Access Compliance Report

Public Rights-of-Way

(Curb Ramps)

Intersection ID: N/A	Main Street: NINA_DR	Cross Street: W_T_HARRIS_BV	Location: NE
ADA ID: 296886A50F69	Ramp Type: PerpDiag	Initial Pass/Fail: Fail	Overall Compliance: No
Codes/Mitigation Info/Possible Solution		Field Measurements/Component Compliance

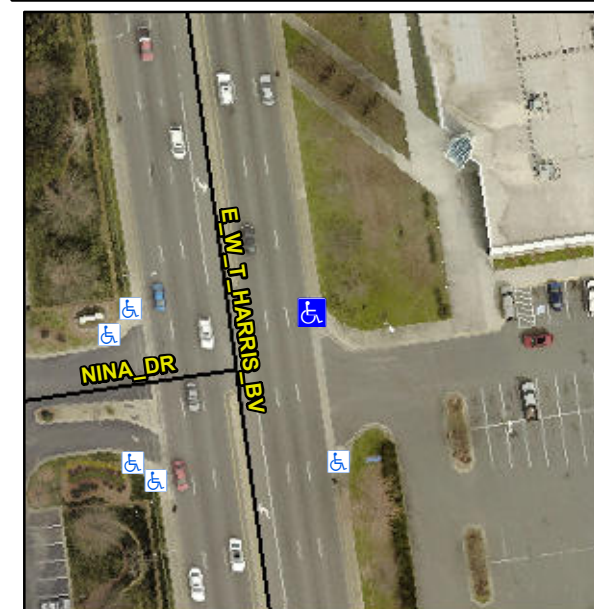
R304.2.2, R304.5.3

Compliance	Description	Data	Compliance	Description	Data
N/A	Ramp Length (in)	61.0	No	Ramp Slope (%)	11.1
Yes	Ramp Width (in)	54.0	No	Ramp XSlope (%)	3.8
N/A	Flare Type LT	N/A	N/A	Flare Type RT	N/A
N/A	Flare Slope LT (%)	N/A	N/A	Flare Slope RT (%)	N/A
N/A	Flare Traversable LT?	N/A	N/A	Flare Traversable RT?	N/A
N/A	Landing Length (in)	N/A	N/A	DWS Provided?	N/A
N/A	Landing Width (in)	N/A	N/A	DWS Contrast?	N/A
N/A	Landing Slope (%)	N/A	N/A	DWS Length (in)	N/A
N/A	Landing X Slope (%)	N/A	N/A	DWS Full Width?	N/A
N/A	Landing Curb? (Y/N)	N/A	N/A	DWS Offset (in)	N/A
N/A	Shared Landing?	N/A			
N/A	Gutter Ponding?	N/A	N/A	Gutter Slope (%)	N/A
N/A	Gutter Lip Ht (in)	N/A	N/A	Gutter X Slope (%)	N/A
N/A	Painted X Walk1?	No	N/A	Painted X Walk2?	No
	X Walk 1 Direction	To W		X Walk 2 Direction	To S
N/A	X Walk 1 Width (in)	N/A	N/A	X Walk 2 Width (in)	N/A
	X Walk 1 Slope (%)	0.9		X Walk 2 Slope (%)	0.8
	X Walk 1 X Slope (%)	1.1		X Walk 2 X Slope (%)	4.4

Remove & Replace Curb Ramp With Two New Directional Ramps or Equivalent.
